1. Type of Well Gas Well Other SWD NOV 17 20					8. Well Name and No. N E SALADO DRAW DEEP FEDERAL 1			
					9. API Well No. 30-025-28967			
3a. Address 3b. Phone No. (includ) 333 West Sheridan Avenue, Oklahoma City, OK 73102-5015 405-552-4615					10. Field and Pool or Exploratory Area SWD;BELL CANYON-CHERRY CANYON

Permanent Abandonment of Federal Wells Conditions of Approval

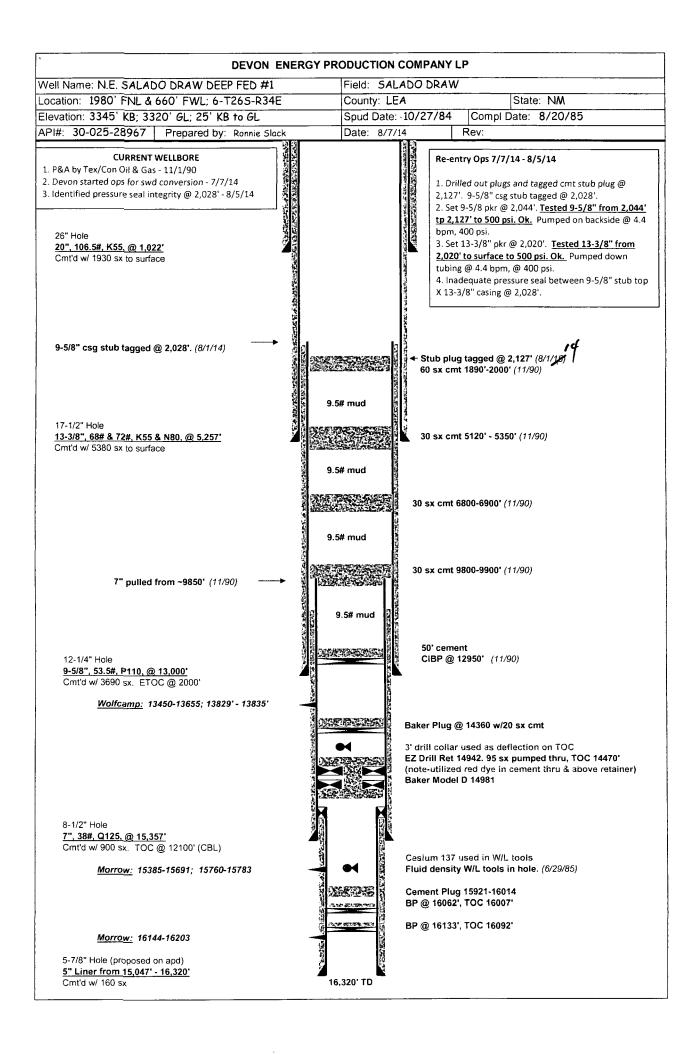
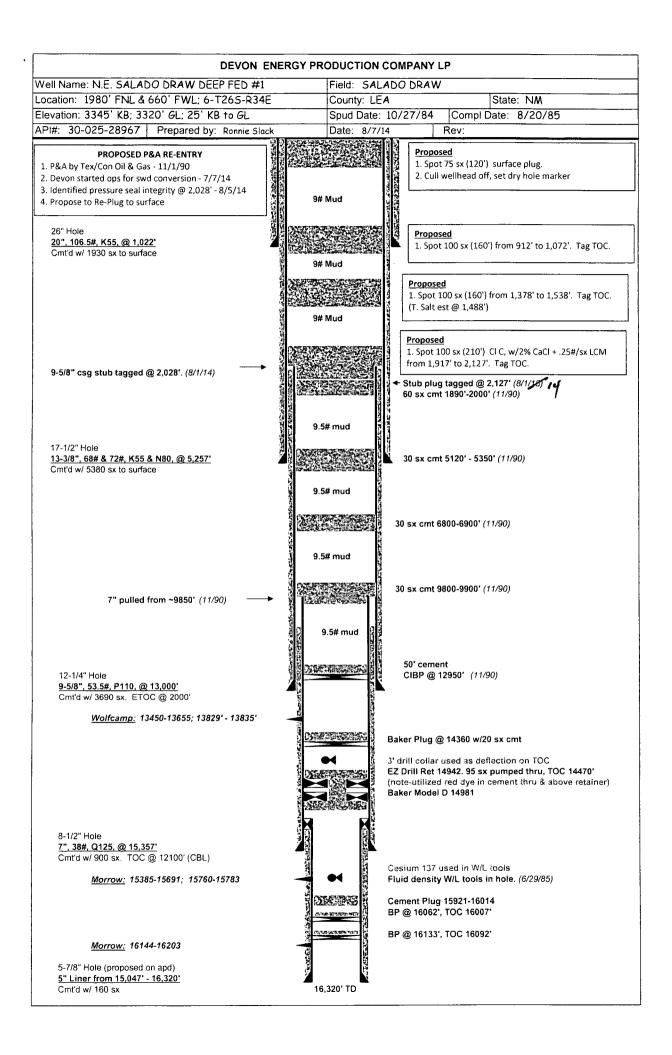
- 4. <u>Mud Requirement:</u> Mud shall be placed between all plugs. Minimum consistency of plugging mud shall be obtained by mixing at the rate of 25 sacks (50 pounds each) of gel per 100 barrels of **brine** water. Minimum nine (9) pounds per gallon. **(9# brine is not mud)**
